LEPPINGTON (1) 88 DEVELOPMENT PTY LTD

BCA ASSESSMENT REPORT

Leppington Site A

Project number: 120011
Revision: BCA Site A 1.0
Date: 28 May 2026

Figure 5: Ground Level Plaza area is roof as open space and allows retail tenancies to exit onto the plaza which is connected to the public road to the north and south. Aqua line indicates where roof as open space is achieved.

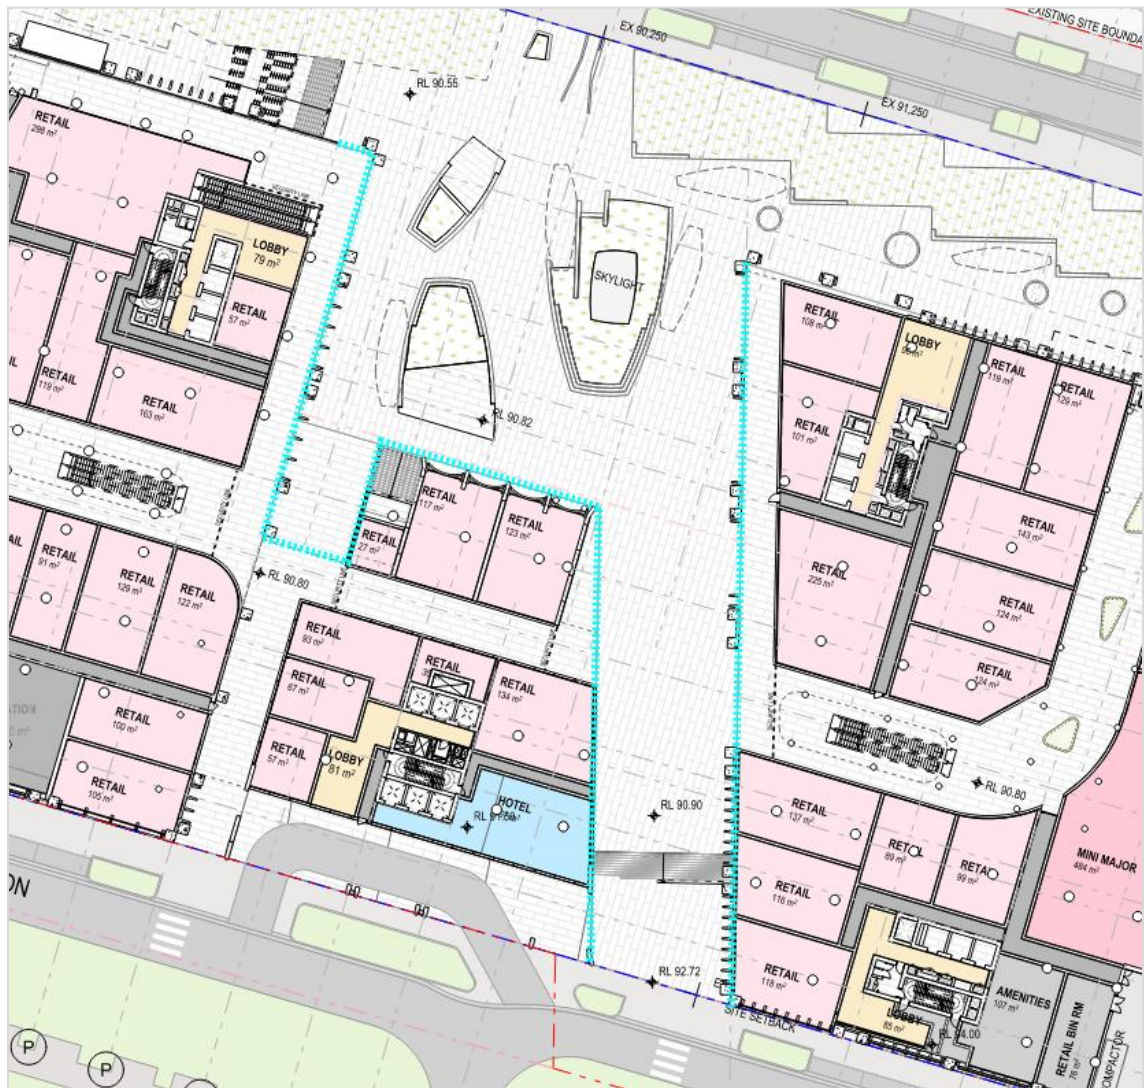
6. Ground Level Retail: Some of the smaller retail tenancies have access to a single exit direct to road or open space as permitted by BCA Clause D2D3(2)(b). This applies to tenancies with direct egress to the northern open space areas, southern public road and the central plaza area which is roof as open space. Refer to Figure 5 below.

Figure 8: Lower Ground: Retail mall area will require an additional exit around the eastern end of the mall to reduce travel distances. Example location of a fire stair is shown above. In addition, the public mall area at

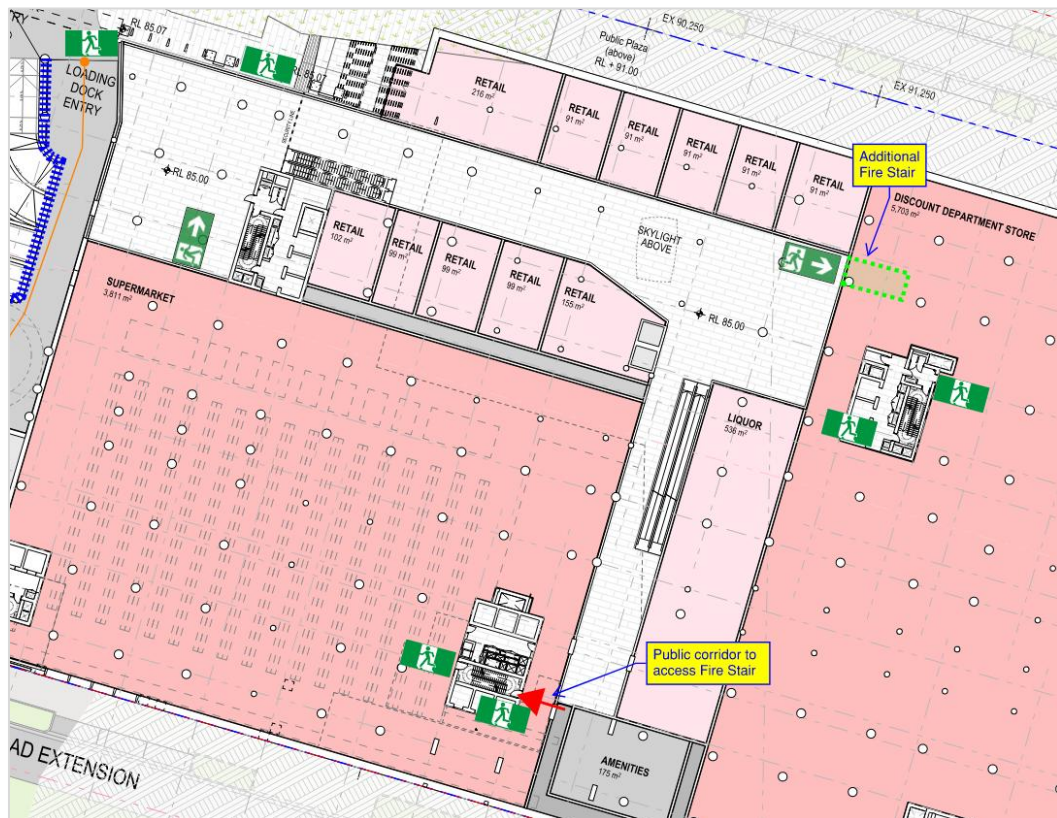
- The retail mall area will require an additional exit around the eastern end of the mall to reduce travel distances. Refer to Part 3.6.1 of the report below for further information.

For example, at Lower Ground level the retail mall area will require an additional exit around the eastern end of the mall to reduce travel distances. Example location of a fire stair is shown in Figure 8 below. In addition, the public mall area at the amenities will require the public corridor to provide access to the fire stair in Building 04 core to reduce travel distances.

the amenities will require the public corridor to provide access to the fire stair in Building 04 core to reduce travel distances.

Figure 9: Podium Level 01 Building 01/02/03 Communal facilities for residents – arrows show proposed egress paths and additional egress paths recommended to reduce travel distances within the acceptable limits for performance-based assessment.

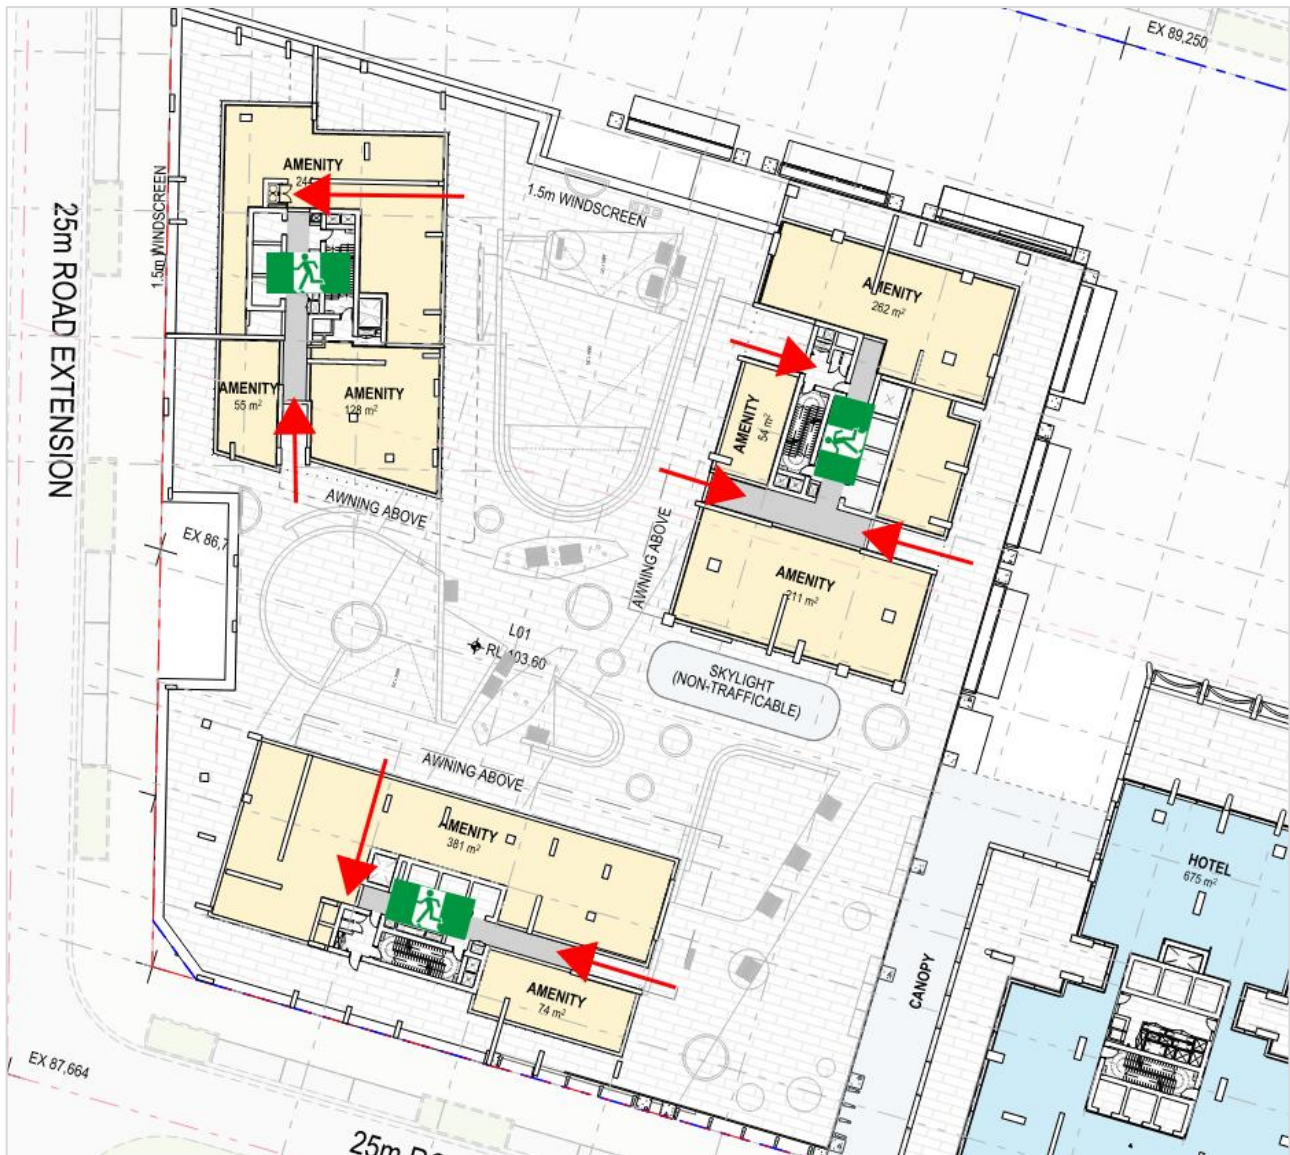
In relation to the residential podium levels with communal facilities for residents, being Level 01 for Building 01/02/03 and Level 02 for Building 05/06 and Building 07/08, the plans show the required exits are generally uniformly distributed around the storey with two fire stairs within each core of each building. The intent for travel distances to be within acceptable limits for performance-based assessment will require minor amendments during detailed design phase to improve travel distance compliance within the acceptable limits for performance-based assessment. Details are to be provided at detailed design phase to outline how compliance will be achieved in consultation with the Fire Safety Engineer. Refer to Figure 9 below for an example of additional egress paths recommended to reduce travel distances.
